November 11, 2019

Product Change Notice - New Slim Rack controllers motorized and towable

Flashes

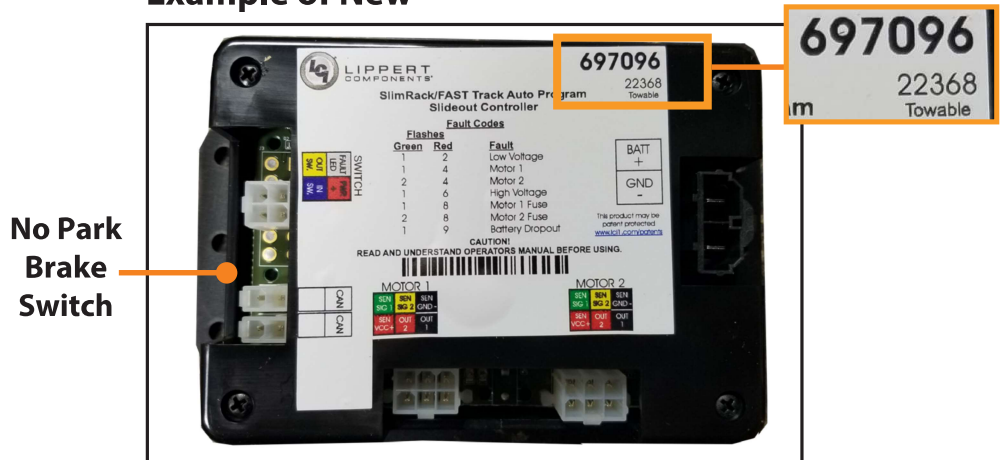
Previously, the fault codes and low voltage behavior were different between manual program and auto program controllers. With the new controllers, there will be unified fault codes for all variants. See the new unified fault codes/ flashes below:

- FAULT_TYPE_PARK_BRAKE = 1 flash.
- FAULT_TYPE_BATTERY_LOW = 2 flashes
- FAULT_TYPE_MOTOR = 4 flashes
- FAULT_TYPE_BATTERY_HI = 6 flashes
- FAULT_TYPE_STOPS_NOT_PROGRAMMED = 7 flashes
- FAULT_TYPE_FUSE = 8 Flashes
- FAULT_TYPE_BATTERY_DROPOUT = 9 flashes
